STATE OF MAINE
DEPARTMENT OF TRANSPORTATION
16 STATE HOUSE STATION
AUGUSTA, MAINE 04333-0016

April 27, 2021
Subject: Highway Lighting
State WIN: 024359.00
Location: **Brunswick**
Amendment No. 1

**BRUNSWICK
LIGHTING SYSTEM**

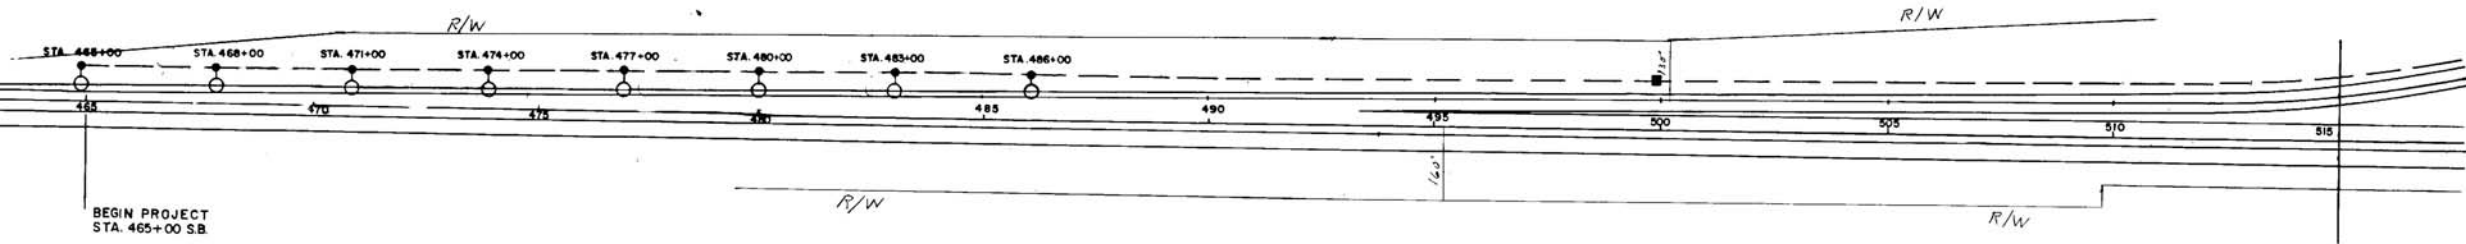
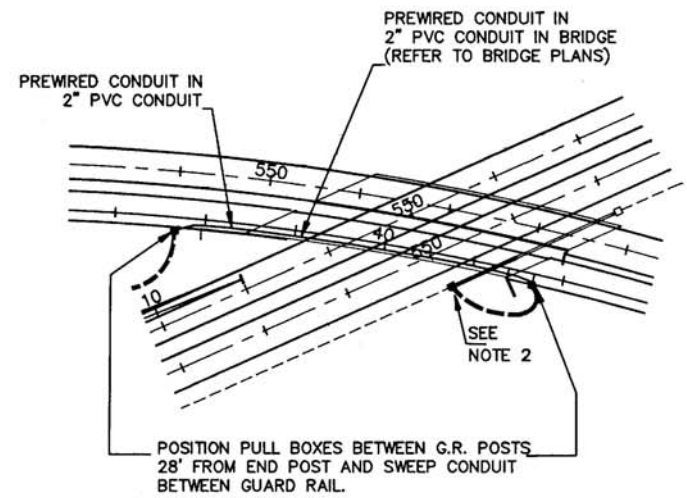
Question: Can you please provide locations for Item # 626.36 Rem Or Mod Concrete Foundations? What size are the foundations? Does the entire foundation need to be completely removed? Do conduit run that are associated with the foundations need to be removed?

Response: "As-built" lighting plans from previous projects at the interchange are attached for reference. The plans indicate approximately 27 foundations (30-inches in diameter). However, some foundations have been removed or are no longer visible reducing the number needed to be removed to approximately 16. Foundations may be removed to a minimum of one foot below the surface grade of the adjacent slope in lieu of complete removal. Existing conduit and junction boxes are intended to be abandoned in place.
